WALLARAH 2 COAL PROJECT
RESPONSE TO LETTER FROM THE PLANNING ASSESSMENT COMMISSION
for
Wyong Areas Coal Joint Venture

Following its review of the documentation for the Project and the public hearing, the PAC provided a letter to Kores on 14 April 2014 seeking additional information regarding four issues:

The questions raised by the PAC in its letter dated 14 April 2014 are addressed in this document.

Ground Profiles Based on Pillars Yielding

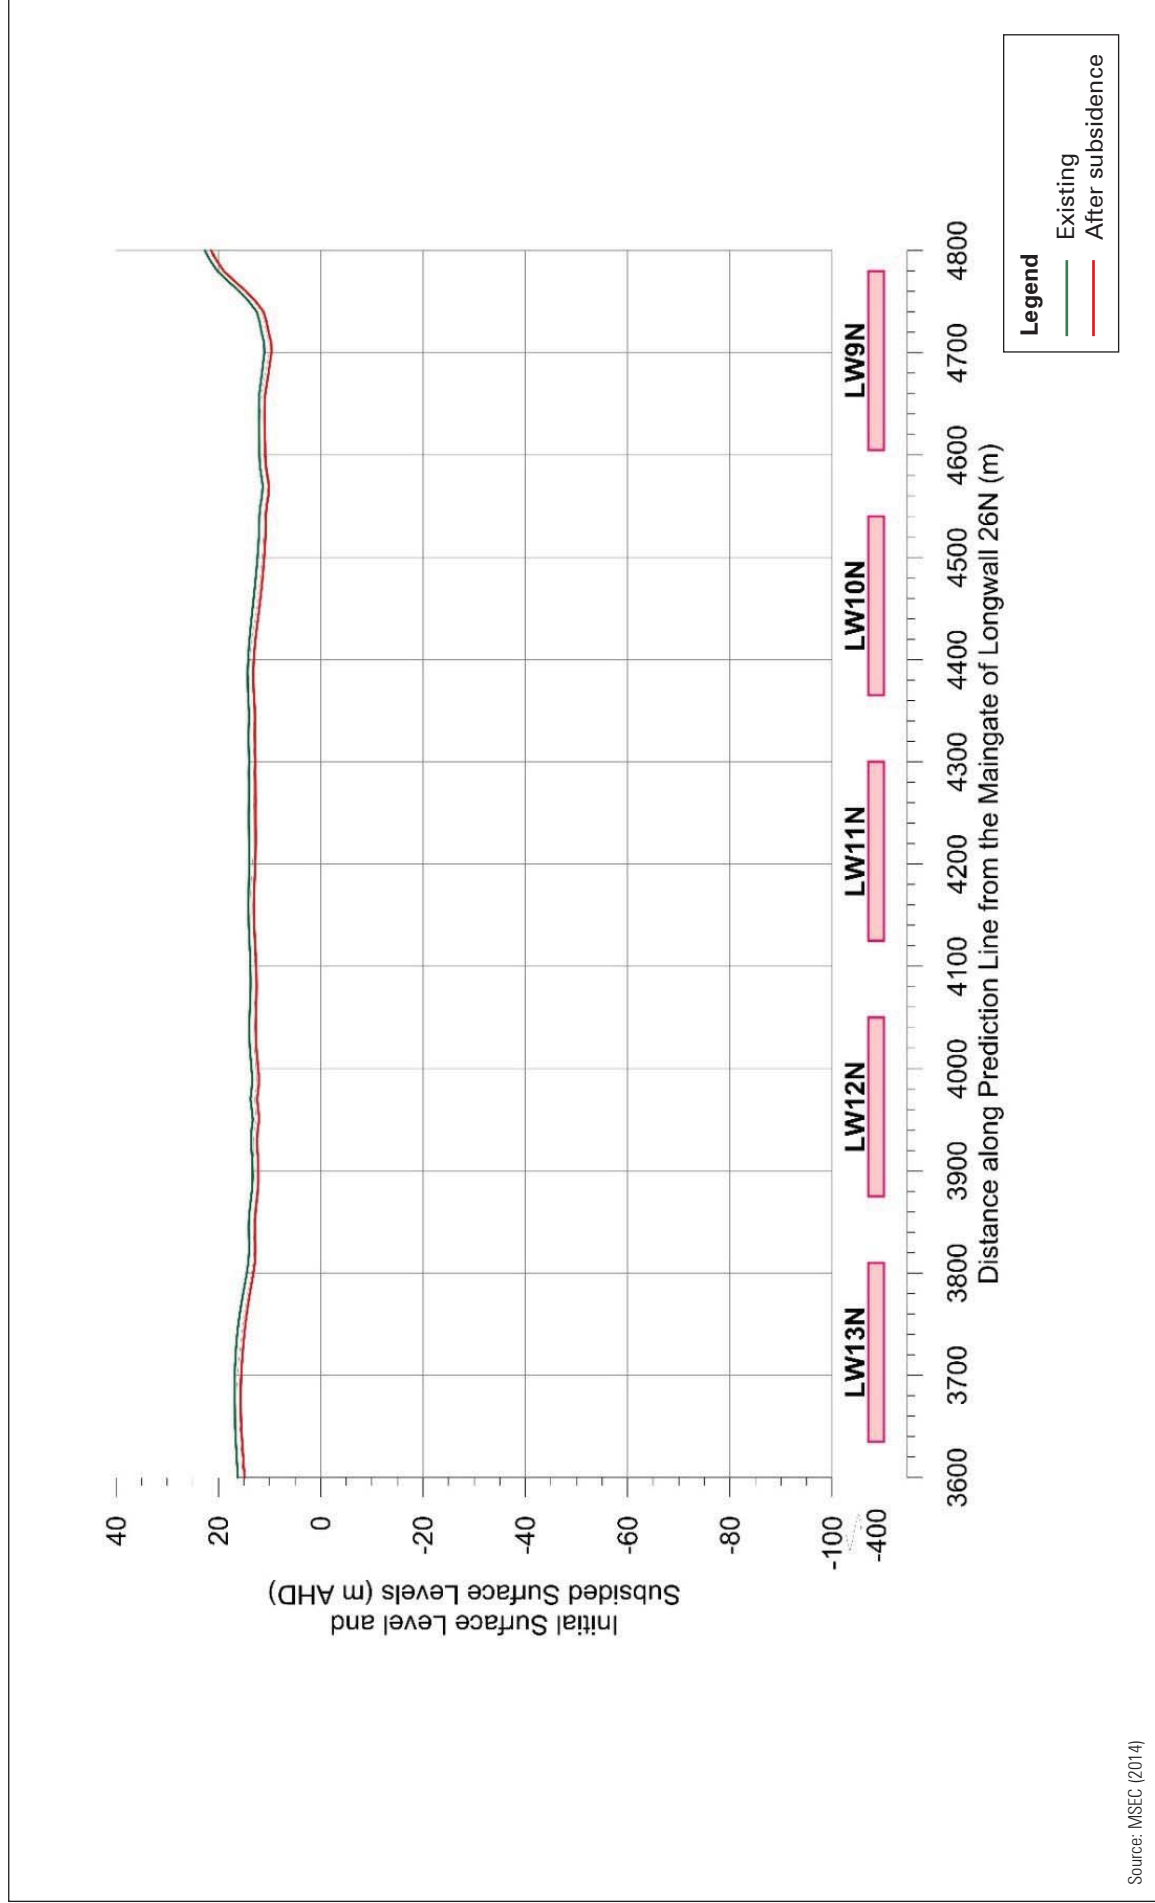
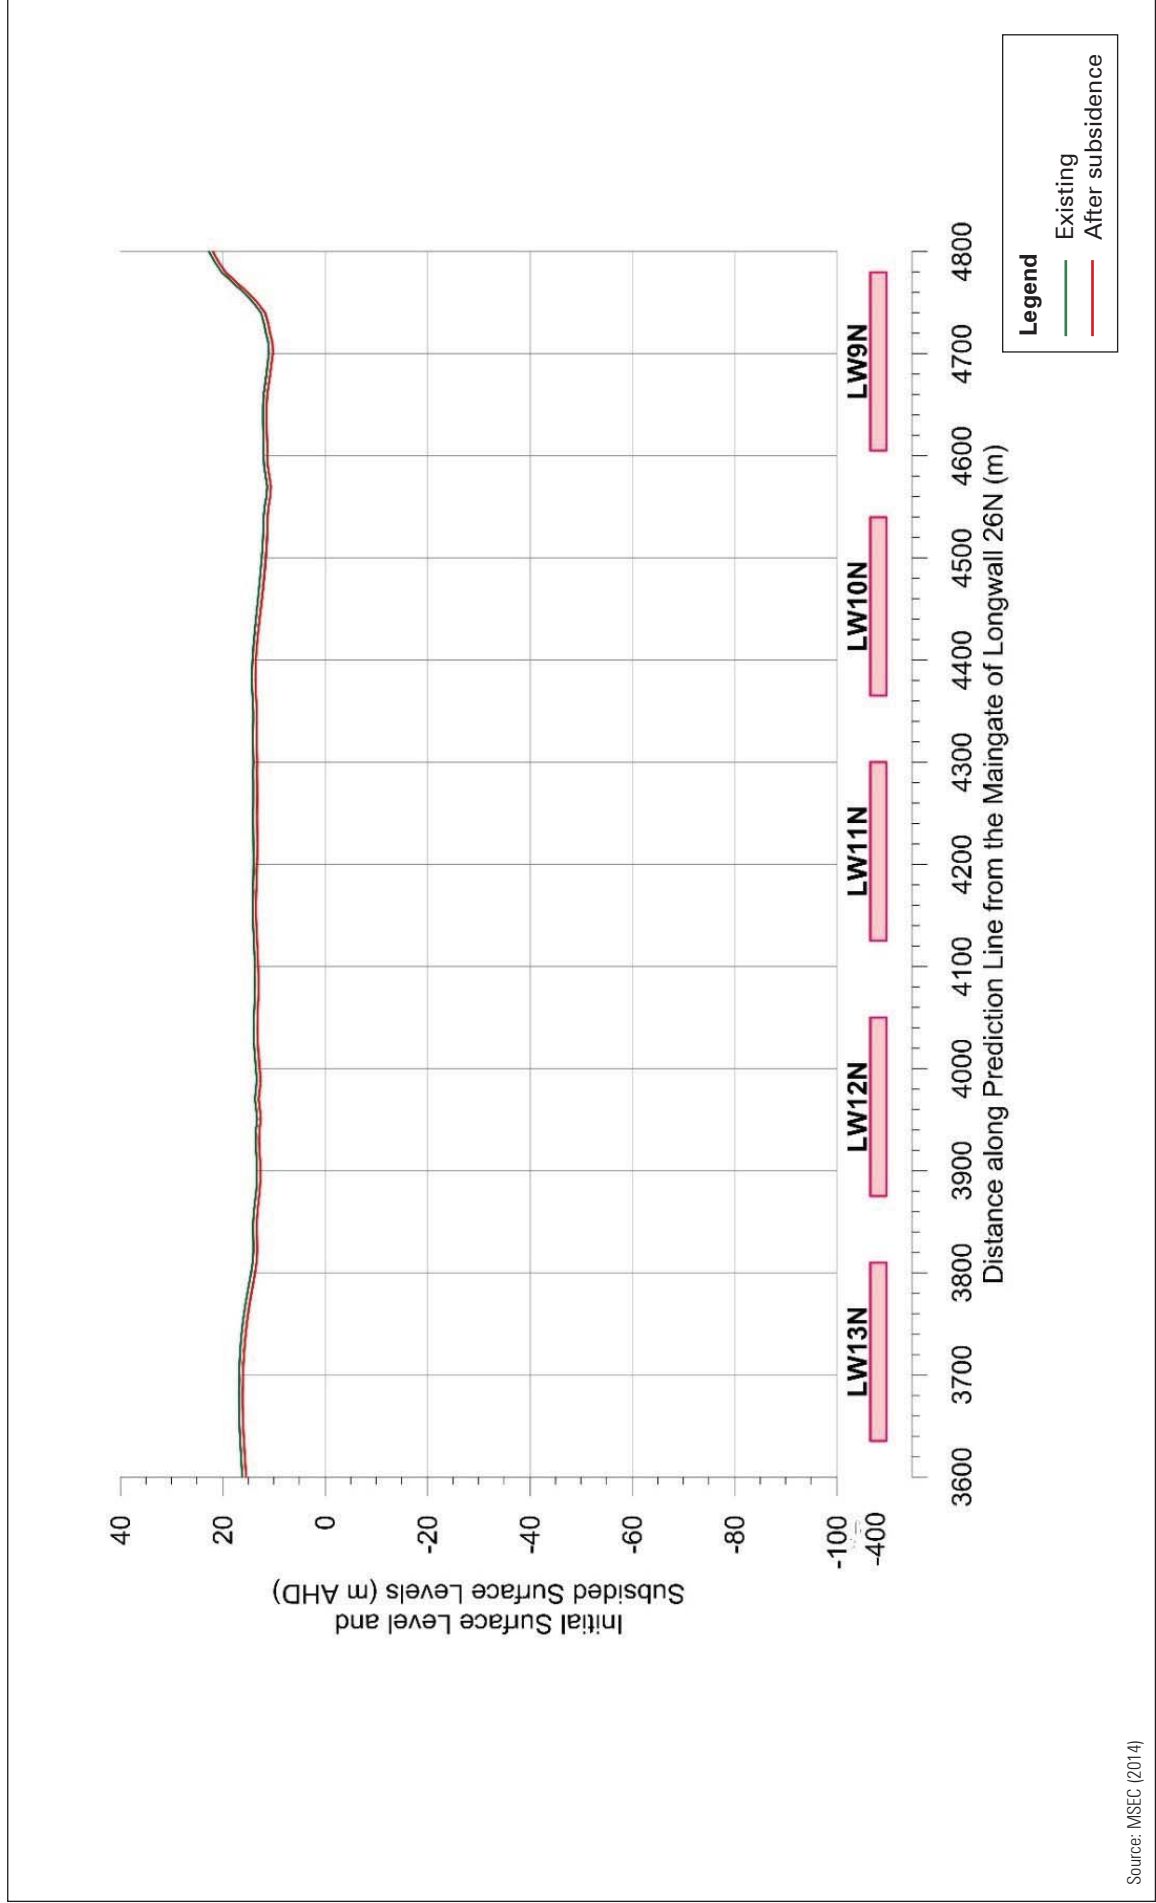
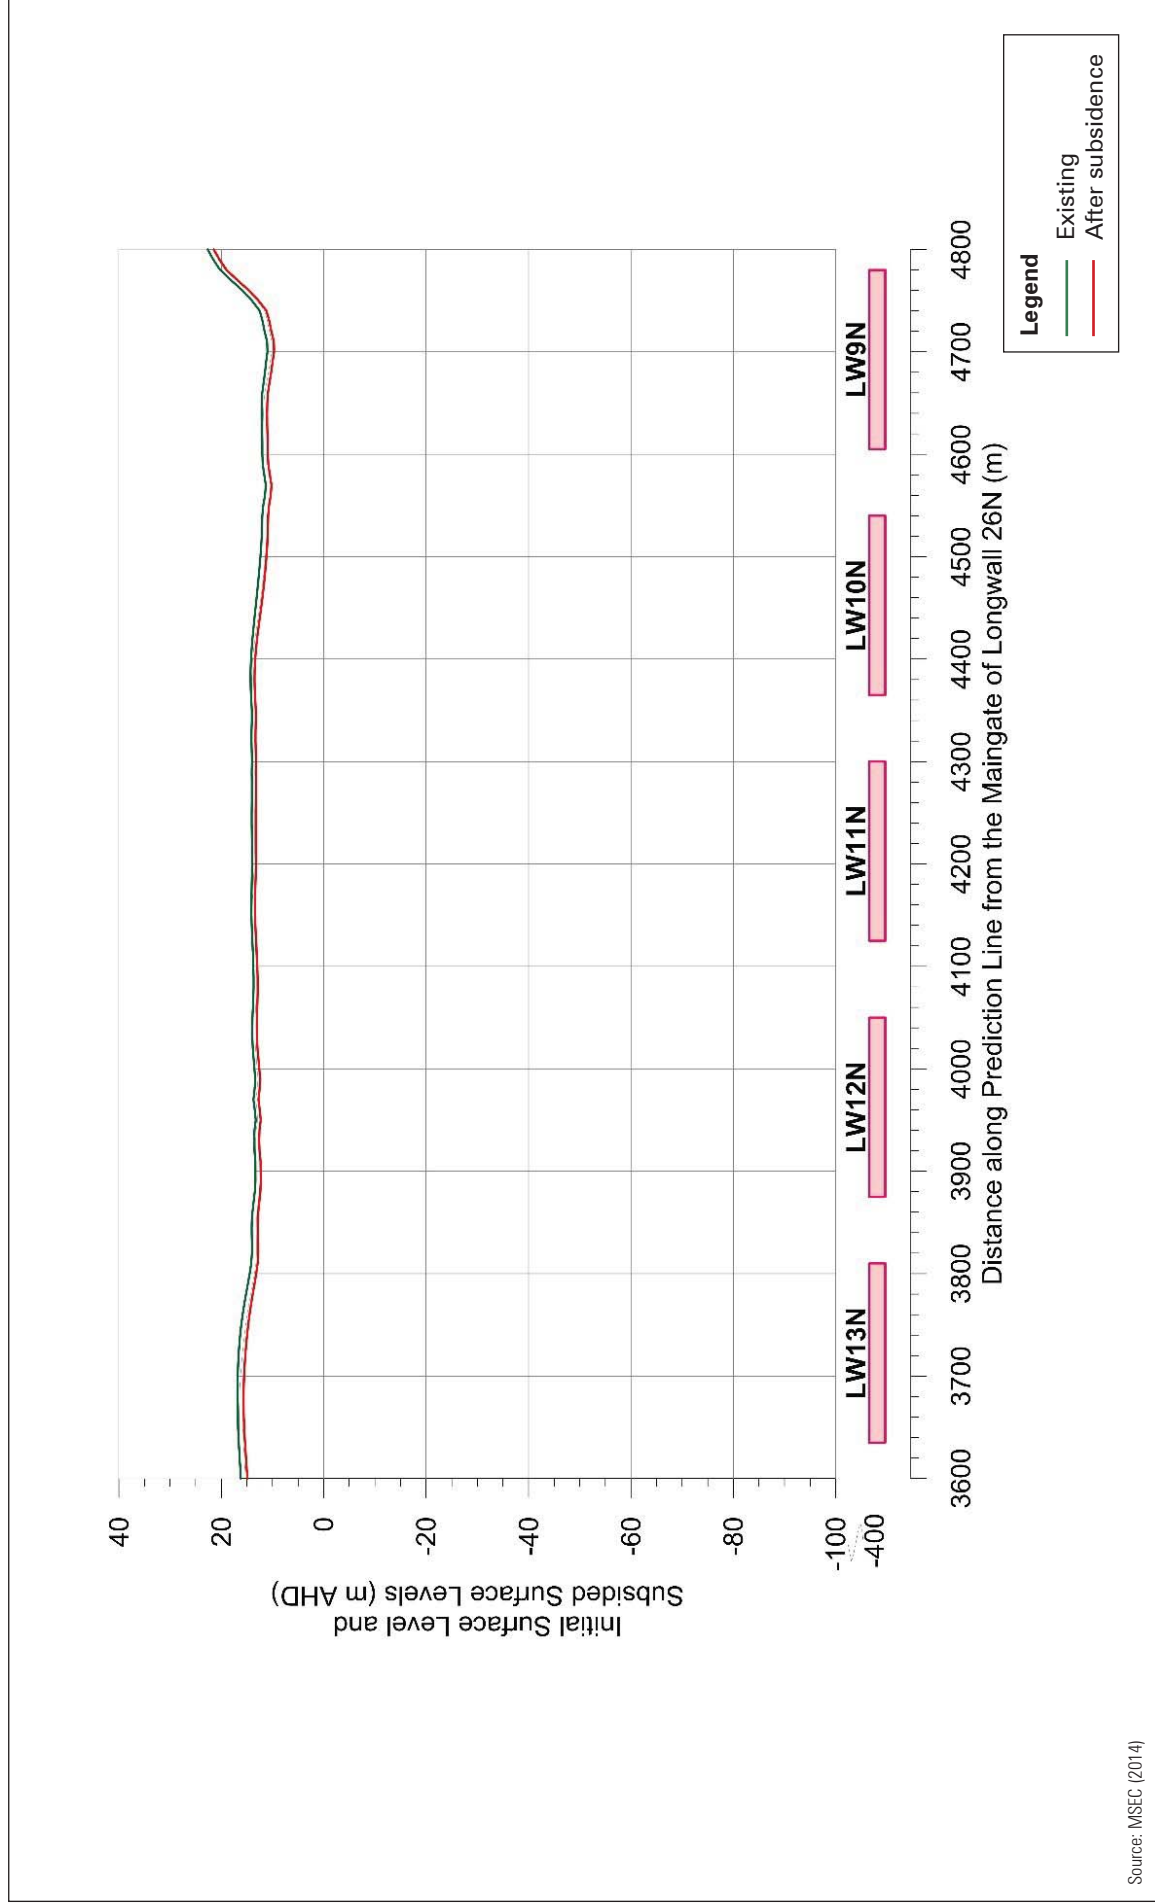
- (i) that uncertainties associated with use of a yielding pillar mine design in the Project Area geology may mean that surface deformation is not as predicted (either in extent or timeframe). What flood studies have been done that incorporate potential variations in surface topography resulting from possible variations in pillar behaviour? What are the potential consequences compared to those predicted?
- (ii) While compensation, modifications, etc., are proposed for potential impacts on existing residences, etc., what is proposed for situations where there is increased risk of flooding on land that would have been suitable for development (e.g. subdivision)? How many properties are in this category (details please)?

The comparative subsidence profiles for the yielded, non-yielded and partially yielded cases are illustrated diagrammatically in **Figure 16**, **Figure 17** and **Figure 18**. In normal scale, the small difference between unsubsided (pre-mining) and subsided (post-mining) topography is indistinguishable on a figure. These figures use a 5:1 vertical exaggeration (500%) in order to show the difference in surface ground levels for the three cases of different pillar response.

Figure 16, **Figure 17** and **Figure 18** show the existing and subsided surface profiles along Prediction Line 1 (refer to Subsidence Modelling Study) resulting from the extraction of the proposed longwalls LW9N to LW13N. **Figure 16** shows the case where the chain pillars yielding due to deep cover and weak floor and roof conditions (the proposed case). **Figure 17** illustrates the case where the chain pillars do not yield despite the deep cover and weak roof and floor conditions (very unlikely case). **Figure 18** shows a theoretical case where only chain pillars at LW11N and LW12N do not yield (very unlikely case).

Figure 16 and **Figure 17** demonstrate that the subsidence is very regular across the profile in both the yielded and non-yielded cases, although involving reduced subsidence in the latter case. Importantly, there is insignificant differential subsidence between the various panels and chain pillars across the profile and this will be within background topographic variation.

The partially yielded pillars case (**Figure 18**) shows only minor and gradual changes in surface gradient.

FIGURE 20

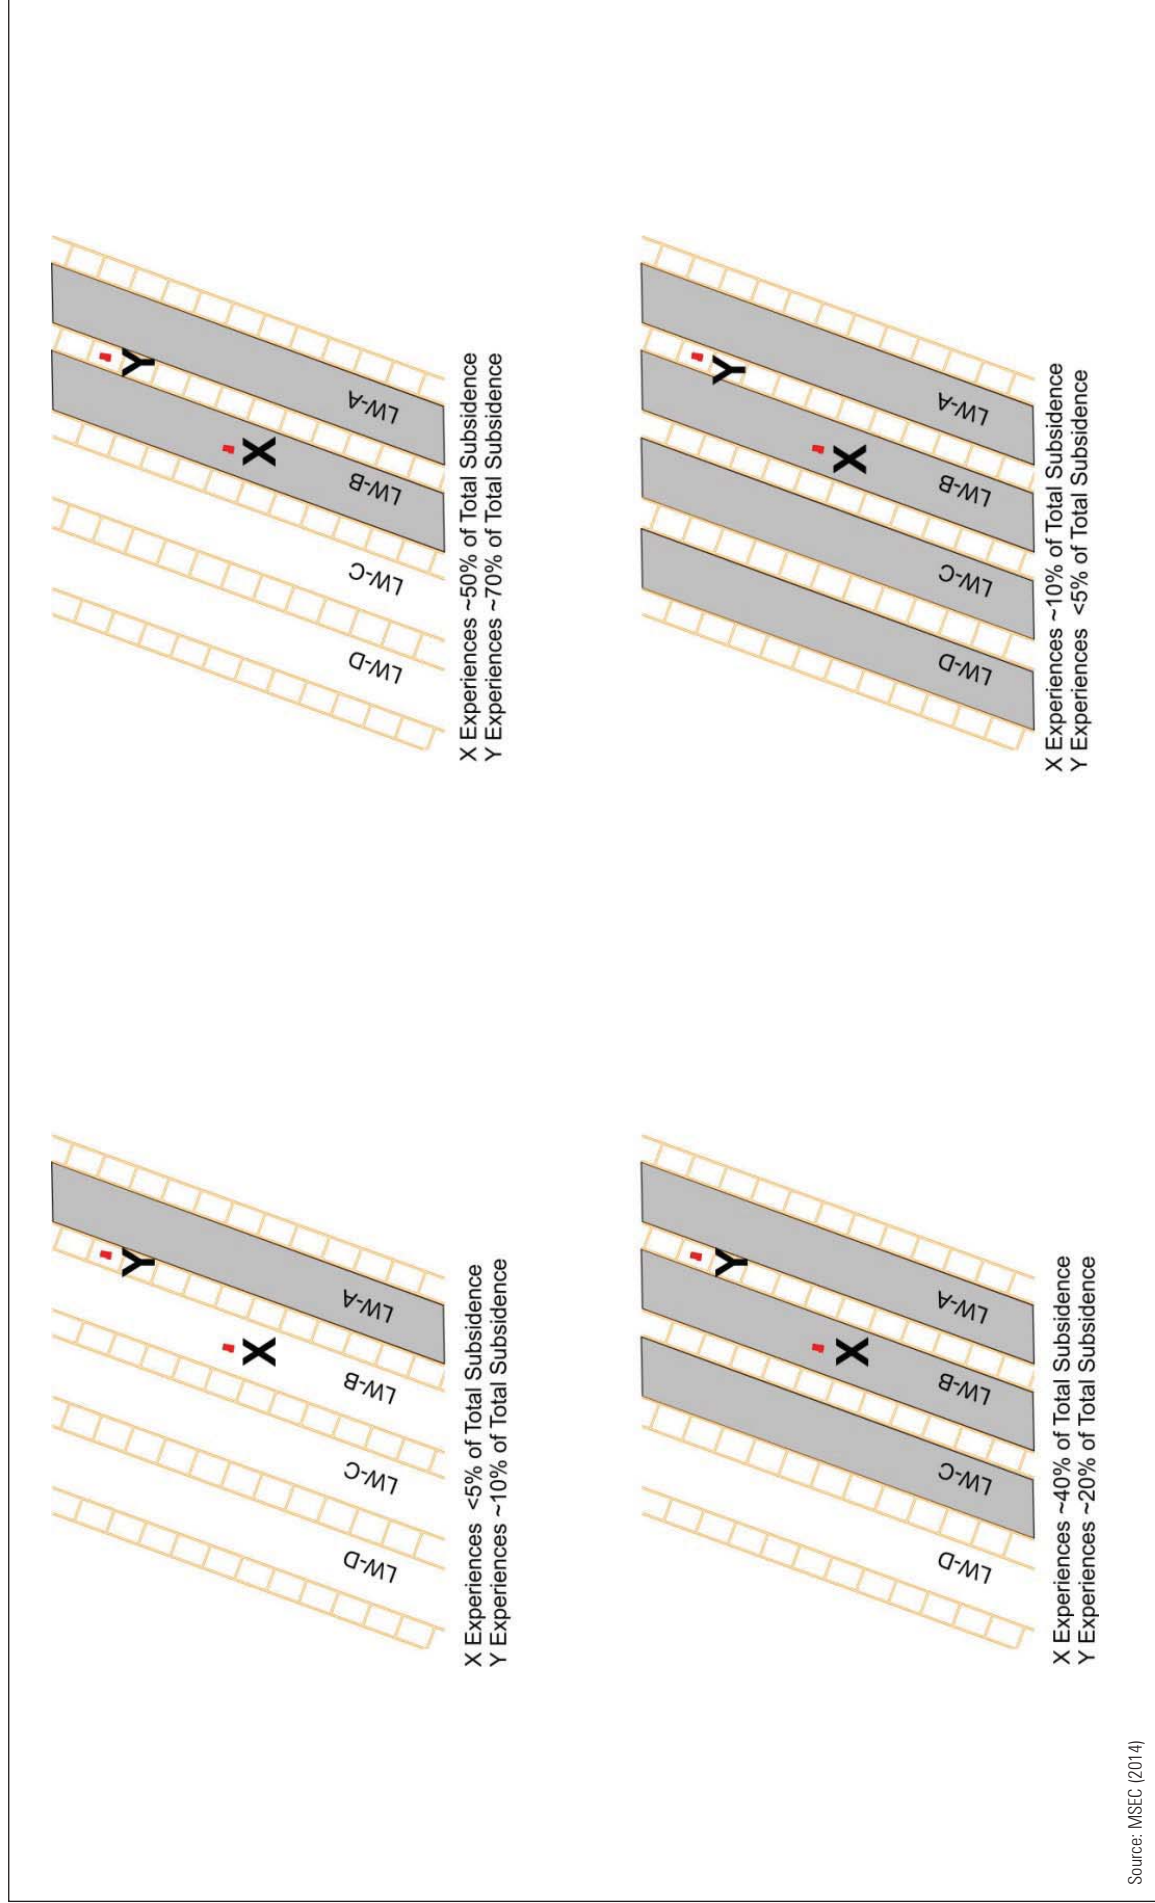
- Timeframes for reaching surface stability.
- (ii) The expected period from initial impact on a feature or built infrastructure to final stability may be affected by the yielding pillar design. Can the Proponent provide estimates of this period of impact for the proposed mining method including the upper bounds.

The extraction of subsequent longwalls in the series, adjacent to a particular location, results in the development of additional subsidence due to the chain pillar compression and reactivation of the existing goaf. **Figure 20** illustrates the subsidence as percentages of the total final subsidence for two locations on the surface: Point X directly above the panel and Point Y directly above the chain pillar.

Figure 20 shows that for a point located directly above a panel, the majority of the total subsidence develops during the longwall which is extracted directly beneath it, with additional but lesser levels of subsidence developing during extraction of the following two longwalls.
